Memorandum

To: Bassett Creek Watershed Management Commission (BCWMC)
From: Barr Engineering Co.
Subject: Item 5B. Consider Approval of Feasibility Study and Choose Concept to Implement for Medley Park Stormwater Treatment Facility Project, Golden Valley (CIP 2022 ML-12) - BCWMC June 17, 2021 Meeting Agenda
Date: June 10, 2021
Project: 23270051.51

5B Consider Approval of Feasibility Study and Choose Concept to Implement for Medley Park Stormwater Treatment Facility Project, Golden Valley (CIP 2022 ML-12)

Medley Park Stormwater Treatment Facility Feasibility Study

Figure 5.3

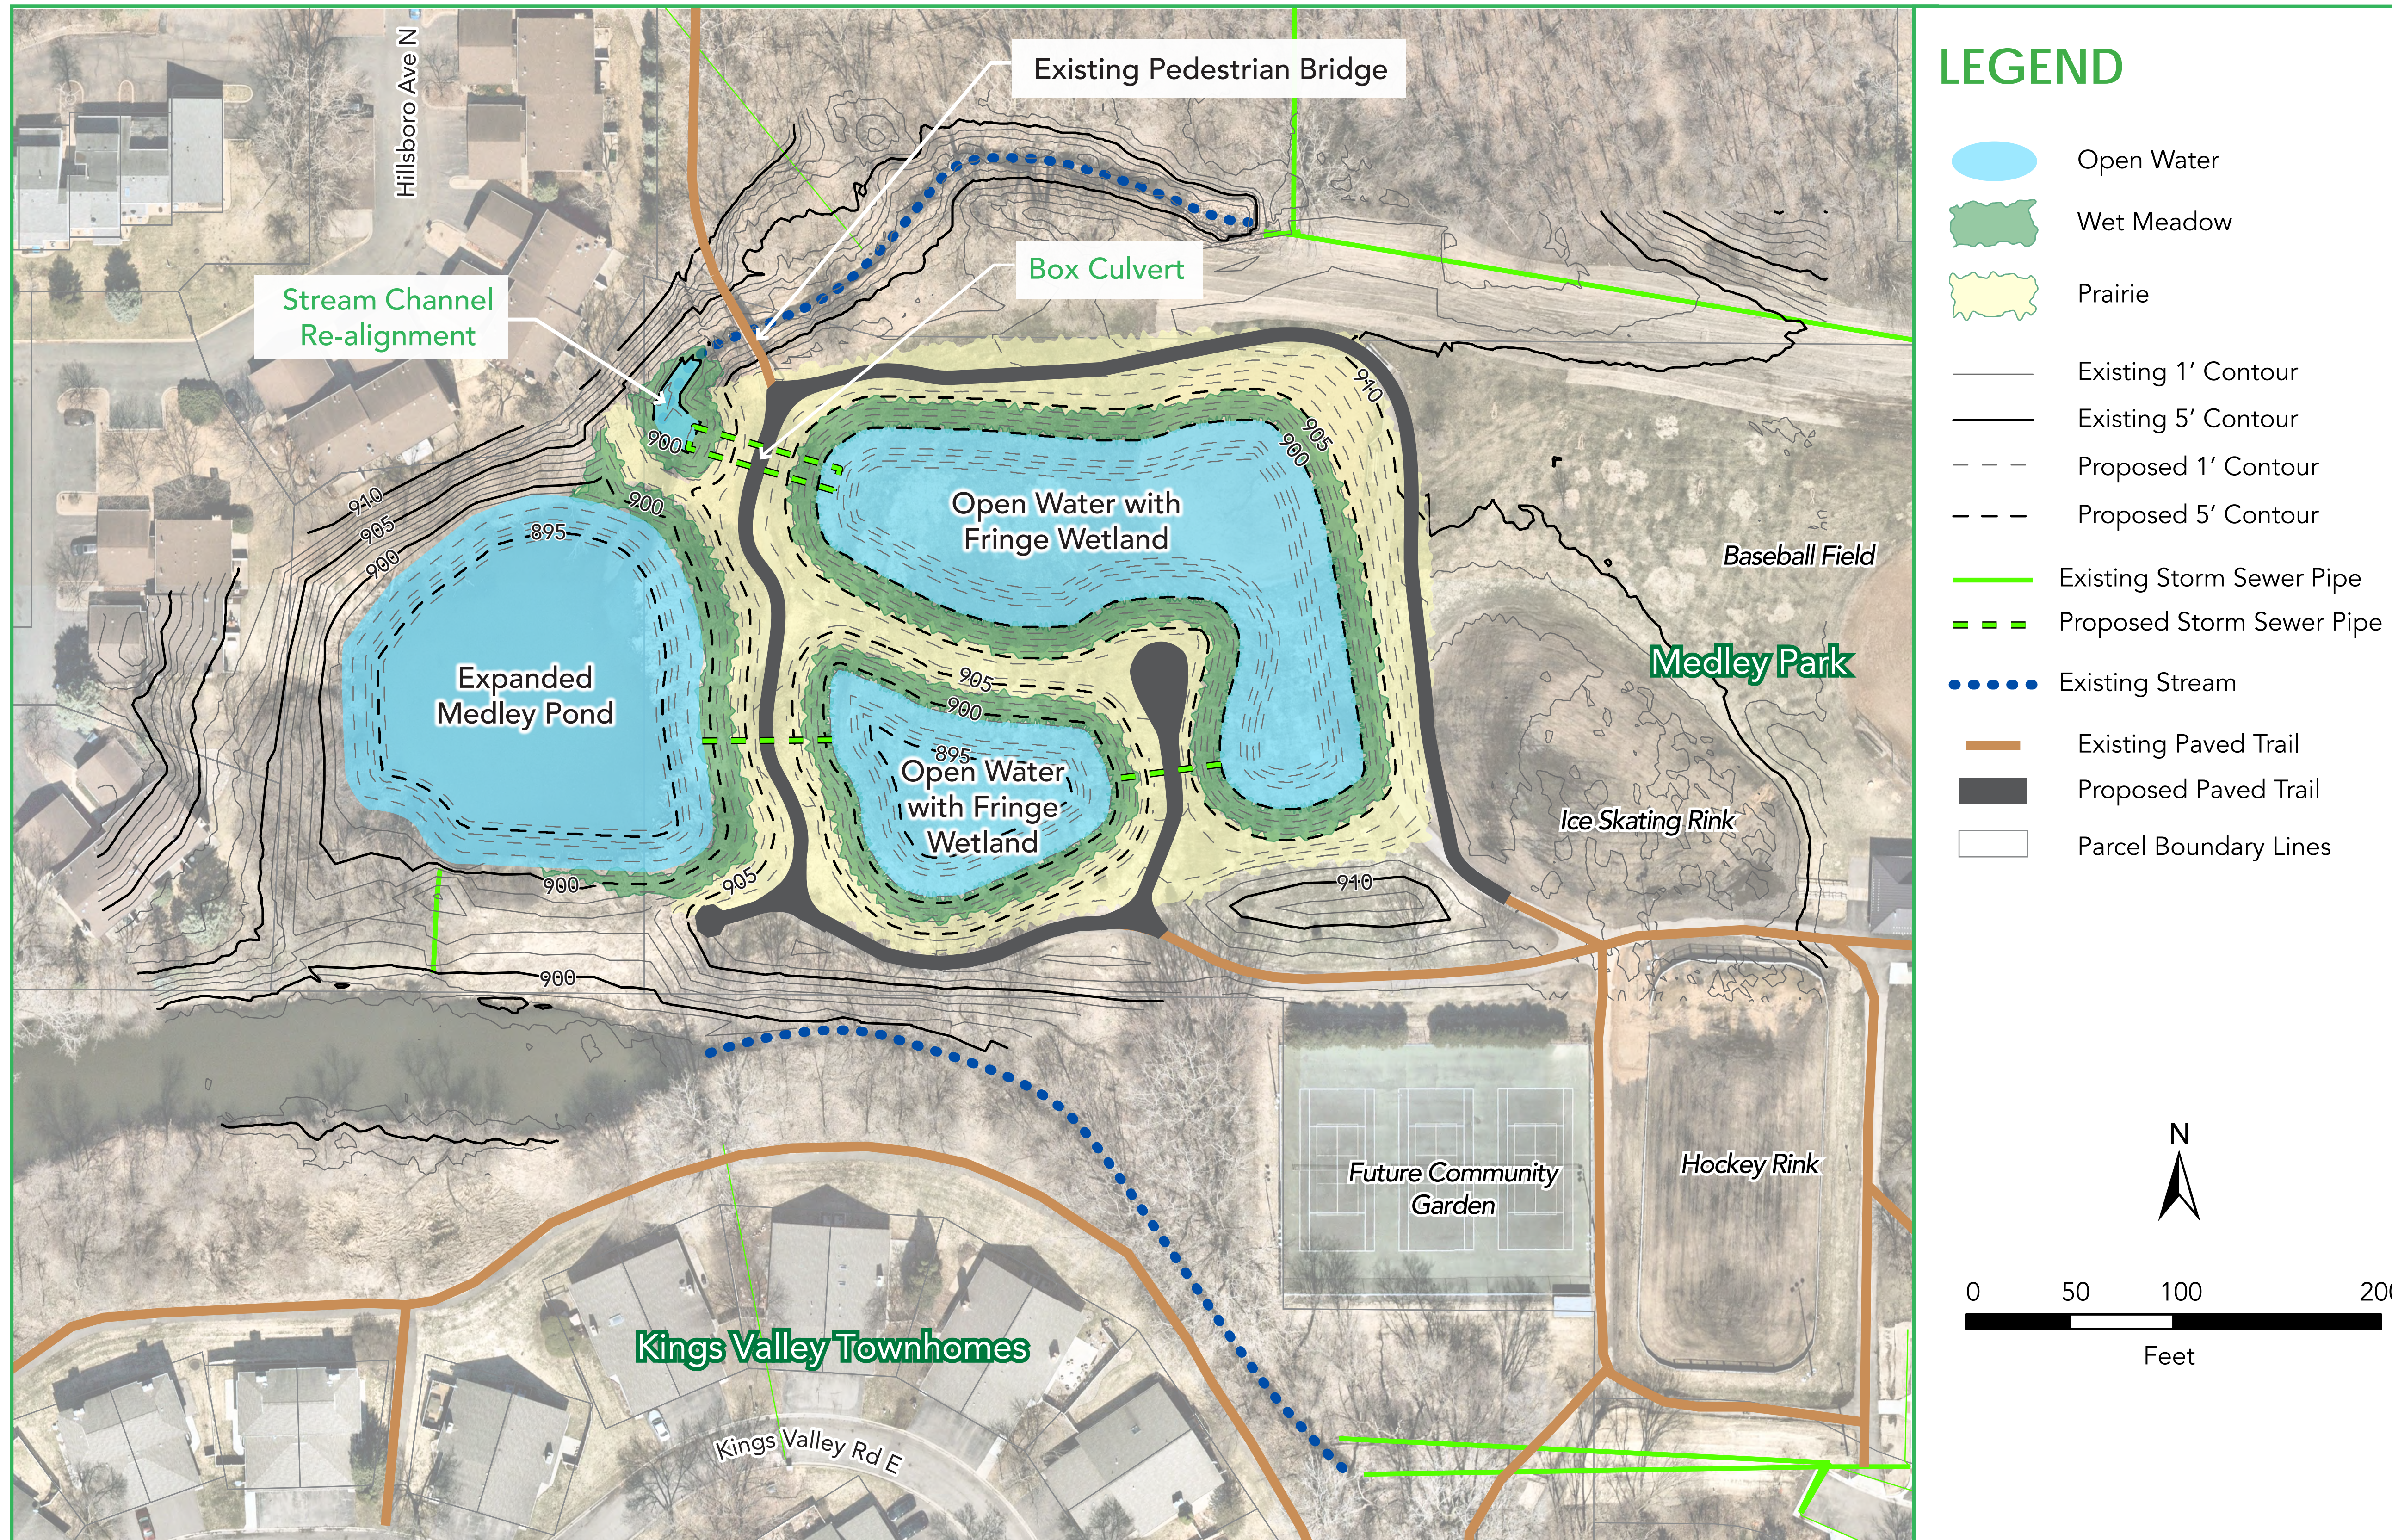
9. Section 5.3 – Concept 3; added text is underlined
 - a. Increasing the total water quality volume by 4.3 acre-feet to 4.6 acre-feet from existing conditions through the expansion of Medley Pond and the excavation and regrading of the western portion of Medley Park. Filtration BMPs that would remove dissolved phosphorus were not included in this concept due to considerable bounce of water levels and long inundation periods for smaller storm events (See Section 8.0 for further discussion on the limitations of dissolved phosphorus removal for Concept 3).
